- 4. Burgin Subdivision; KPB File 2024-070**
Edge Survey & Design / Burgin & Ray Trust
Location: Sterling Highway & Mugzy Avenue
Ninilchik Area

**ITEM #4 - PRELIMINARY PLAT
BURGIN SUBDIVISION**

KPB File No.	2024-070
Plat Committee Meeting:	June 22, 2024
Applicant / Owner:	Burgin and Ray Trust Dated October 22, 2007 / Anchorage, Alaska
Surveyor:	Mark Aimonetti / Edge Survey and Design, LLC
General Location:	Sterling Highway and Wildrose Lane, Ninilchik

STAFF REPORT

BURGIN SUBDIVISION

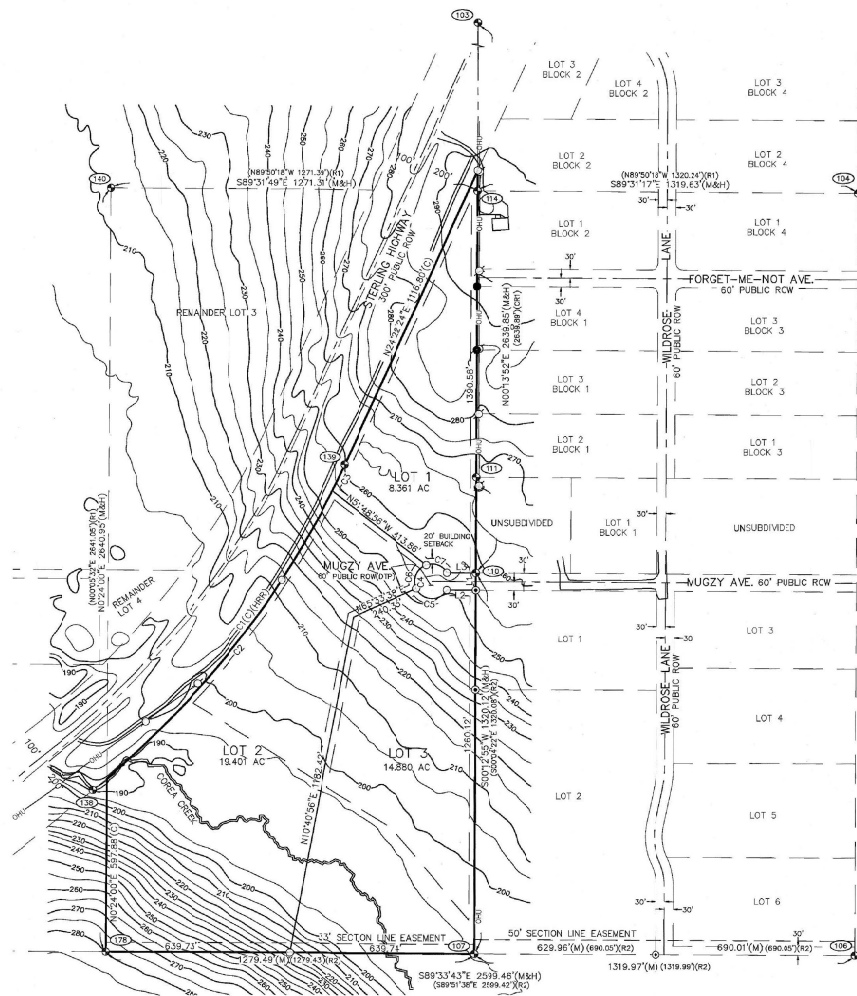
There are steep areas as shown by the contours on the plat. They should be clearly indicated as being steep on the final plat with a label of "steep" and direction of the slope. The contours can be removed for the final plat submittal.

Wetlands are also crossing the plat, coinciding with the low area of Corea Creek. The wetlands should be shown on the final and plat note 5 should remain on the final as well. The River Center review did not indicate the plat to be in a FEMA designated floodplain or flood hazard zone. Plat note 6 should be verified with the River Center, and if not applicable, should be removed.

- In the legend, the lines for 20' building setback and overhead utility line need changed to represent the correct line being used. Check others for correctness also as it appears interior lot line, edge of gravel, and bank of creek may be the same.
- Verify the use of (R3) as it appears to be missing from the plat. If it is not used,
- Add the date of July 22, 2024 to plat note 3.
- Add distance and bearing from the SW1/16 to the north point of subdivision.
- Verify details of monuments 110 and 111.
- Additional items as outlined below.

- Roads must meet the design and construction standards established by the borough in order to be considered for certification and inclusion in the road maintenance program (KPB 14.06).
- The borough will not enforce private covenants, easements, or deed restrictions per KPB 20.60.170.
- Add plat note for CTP item 17.
- Add plat note as requested by DOT.

Adjust legal description to include that part of Government Lot 2 lying south of the Sterling Highway as there is part above the CW1/16 marker.

Add the KPB Number 2024-070.

Darken the section line on the vicinity map

Label and show Wildrose Ln and Mugzy Ave on the east

Label Corea Creek

Label section 12

33' section line easement needs shown on the southwest line of the subdivision.

Plat identifiers need added to the east

Government lots need labeled to the north and south.

Unsubdivided parcels needed labeled on the southeast and southwest.
Adjust 20' setback and OHU in legend
Verify interior lot line, edge of gravel, and bank of creek are different in legend

- H. Approximate locations of low wet areas, areas subject to inundation, areas subject to flooding or storm water overflow, and the line of ordinary high water. This information may be provided on an additional sheet if showing these areas causes the preliminary plat to appear cluttered and/or difficult to read;
Staff recommendation:
Low wet areas need shown and identified on the plat
- M. Approximate locations of slopes over 20 percent in grade and if contours are shown, the areas of the contours that exceed 20 percent grade shall be clearly labeled as such;
Staff recommendation:
Label steep areas on the plat

- B. Upon submittal of a preliminary plat, the planning department shall provide a copy to public utility companies for their comments-and recommended design of utility easements. If the property is subject to existing natural gas or petroleum pipeline easements, a copy shall also be furnished to the appropriate company for comment.
HEA requested easements be shown and added

Add “and public areas to public use” after “rights-of-way” in the Certificate of Ownership

Add Certificate for Acceptance

Update date in Plat Approval to July 22, 2024

Add details for found monuments of record in the legend

Verify monuments 110 and 111 for accuracy as they appear the same in detail

BURGIN SUBDIVISION

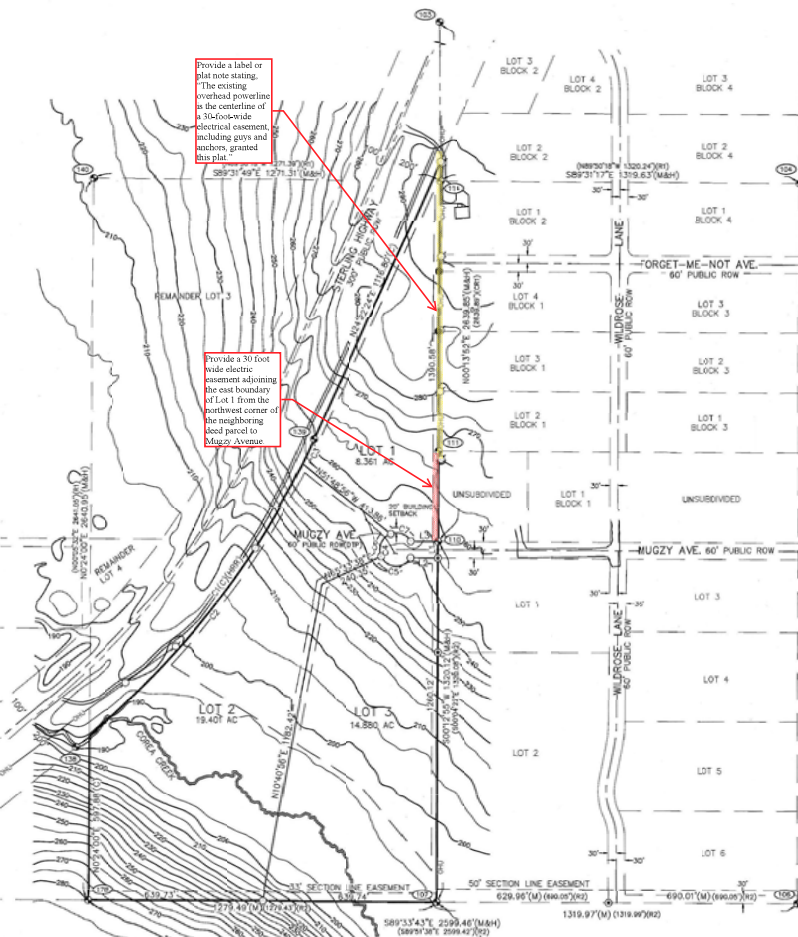
- Please add as a plat note: “No direct access to Kenai Spur Highway for Lot 1A.”
- **Burgin Subdivision (KPB 2024-070)**
 - No direct access to Sterling Highway will be granted for Lot 1, Lot 2, and Lot 3. All proposed lots must take access from Mugzy Ave as shown on the proposed plat.

- Please add as a plat note: “No direct access to the Sterling Highway for Lot 1, Lot 2, and Lot 3.”
 - DOT&PF recommends development of Forget-Me-Not Ave. and that internal lot development not preclude access to Forget-Me-Not Ave.
